IBM27-82660 Errata Summary Revision 1.2

MPR660ESU–03

This document details differences between the operation of the 660 Bridge chipset as described in the IBM27–82660 PowerPC to PCI Bridge User's Manual*, IBM document number MPR660UMU–01, and the actual operation of the Revision 1.1 chipset (IBM27–82663 Rev. 1.0 and IBM27–82664 Rev. 1.1). Where applicable, workarounds are described.*

For the IBM27-82660 Rev. 1.1 (IBM27-82663 Rev. 1.0 and IBM27-82664 Rev. 1.1)

Figure 1. Generic Implementation PAL Installation

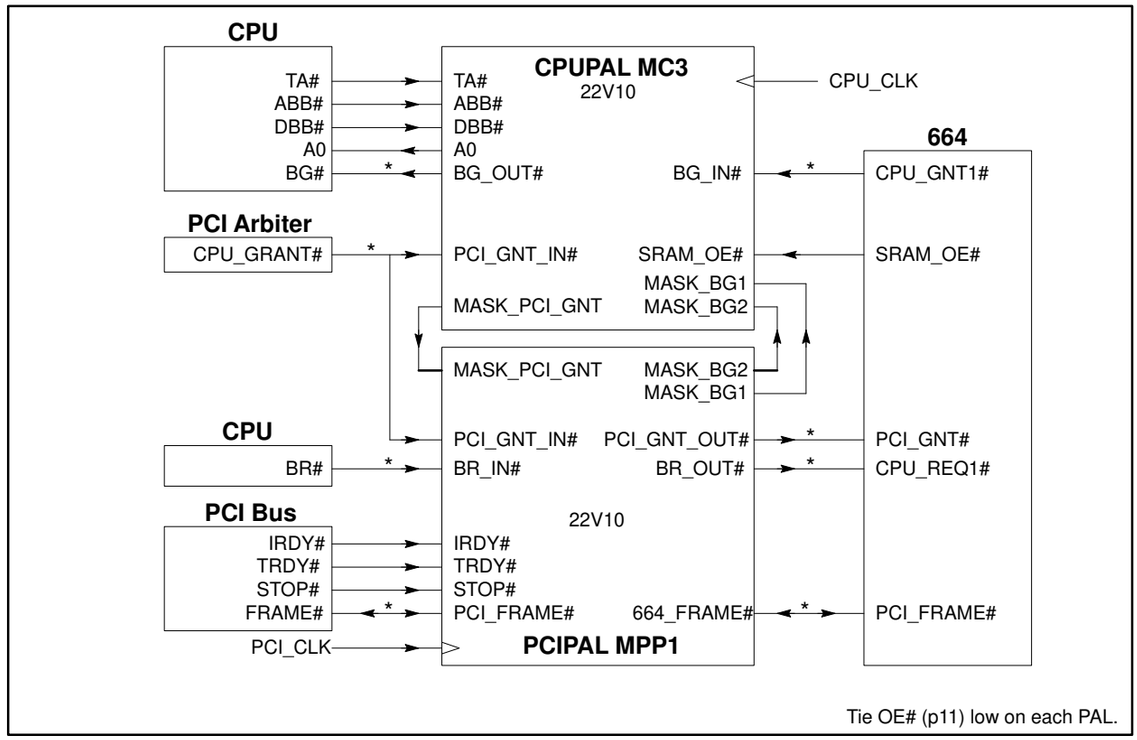
Figure 1 shows a typical installation of the workaround PALs in a generic 603e/604 uniprocessor system.

PAL connections shown without an asterisk do not require any nets to be cut. Merely connect the PAL pin to the an existing net (eg: TA#) or, in the case of the clocks, to another clock driver output.

* Cut these nets between the 664 and everything else. Then connect the PALs to each side of the cut as shown.

Figure 2. Generic Implementation PAL Installation

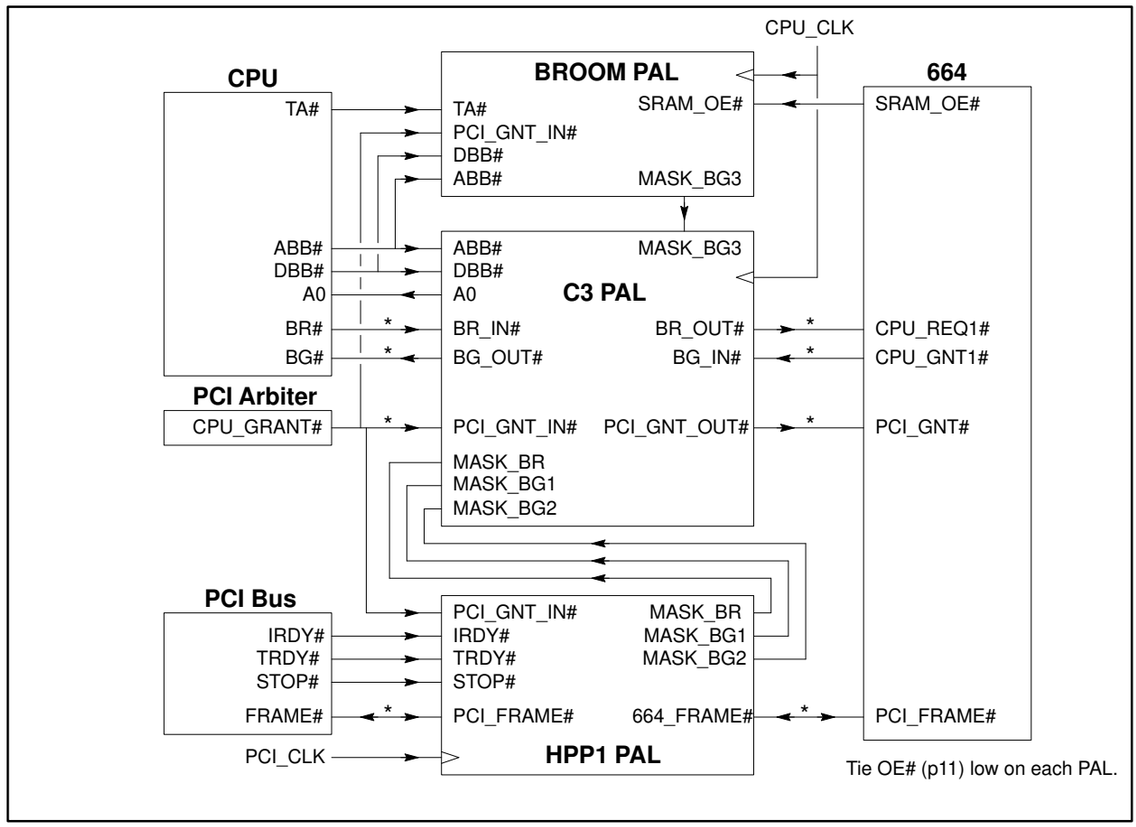
Figure 2 shows a typical installation of the workaround PALs in a generic 603e/604 uniprocessor system.

PAL connections shown without an asterisk do not require any nets to be cut. Merely connect the PAL pin to the an existing net (eg: TA#) or, in the case of the clocks, to another clock driver output.

* Cut these nets between the 664 and everything else. Then connect the PALs to each side of the cut as shown. For example, cut the PCI_FRAME# net at the 664, connect only the 664 PCI_FRAME# pin to the 664_FRAME# pin of the HPP1 PAL, and connect all other devices on the FRAME# net to the PCI_FRAME# pin of the HPP1 PAL.
